MCPB
Item #
7/1/10

MEMORANDUM

REVIEW TYPE: Preliminary Plan of Subdivision

PROJECT NAME: Boxwell Property

Exhibit 2: Preliminary Plan

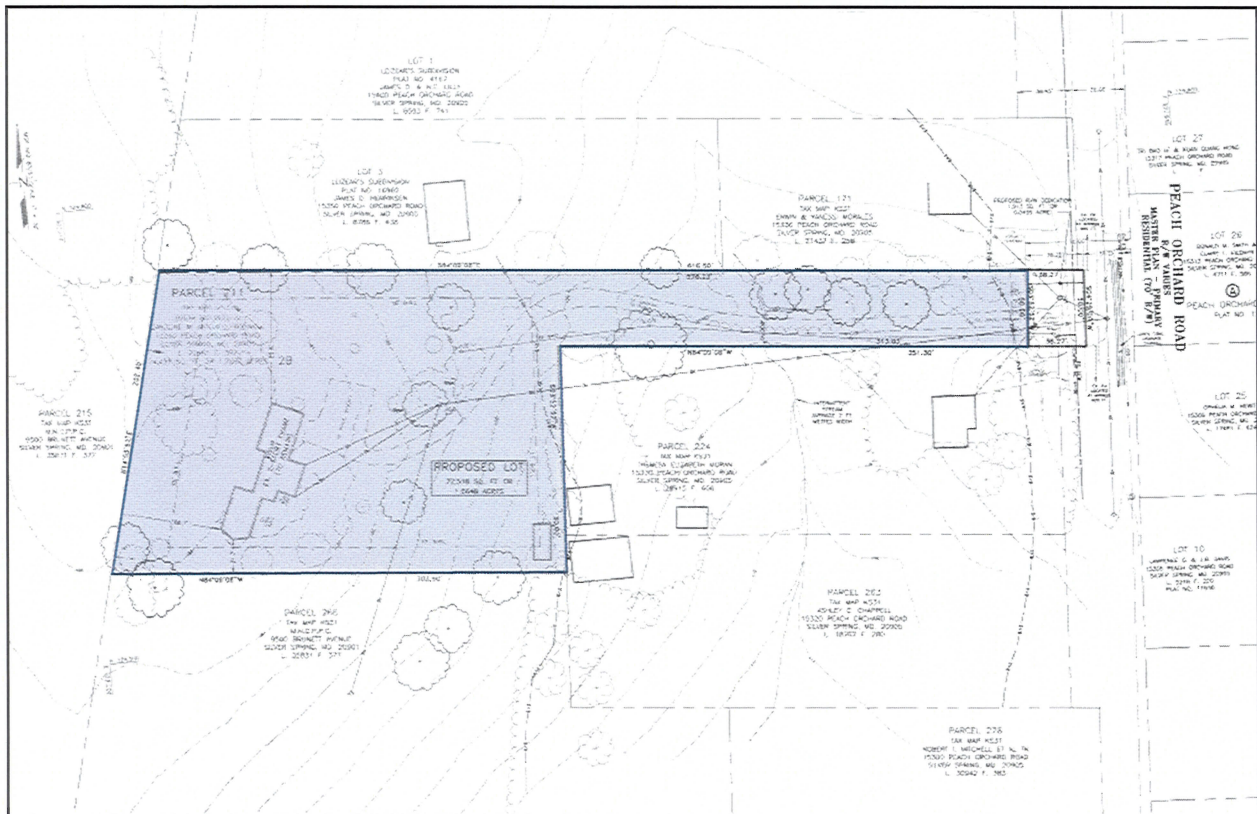
Access from Peach Orchard Road via a private driveway is also proposed to remain. No trees are proposed to be removed on the Property at this time. The existing impervious area on the Property is 14.8%, which is permitted to remain under the grandfathering provisions of Section 59-C-18.152 (a)(1)(A) of the Montgomery County Code, discussed in greater detail in the environment section on page 5 of this report.

The existing site has 11,037 square feet of impervious surfaces, or about 14.8 % of the site. These include the existing house, patio area, walkway, driveway, and a small portion of Peach Orchard Road that lies within the Property. Since there is an existing house that lawfully existed prior to July 31, 2007, the site imperviousness for this project can exceed the 8% cap but cannot be increased over what exists today.

Although the proposed preliminary plan shows the existing house will remain as is, the Applicant has indicated that the house may be either reconstructed or demolished and a new house built. Since a house exists on the site, and the residential use is to remain, staff recommends that if and when the house is reconstructed or replaced, an impervious limit that is equivalent to the imperviousness that occurs on the site today should be applied. This would be consistent with the Environmental Overlay Zone.

The pipestem portion of the property lies within the environmental buffer of the intermittent stream that flows through the site. Since vehicular access to the site can only occur along the

pipestem, the existing driveway cannot be relocated outside the buffer. Staff does not recommend the placement of a conservation easement over the environmental buffer.

- a. Prior to recording of plat, the Applicant must enter into an agreement with the Planning Board to limit impervious surface to no more than 14.8 percent (or 11,037 square feet) of the property acreage of 1.7 acres.

- b. Prior to release of building permit, the Applicant must demonstrate conformance to the impervious surface limit. Any modifications to these plans which increase imperviousness will require Planning Board action.
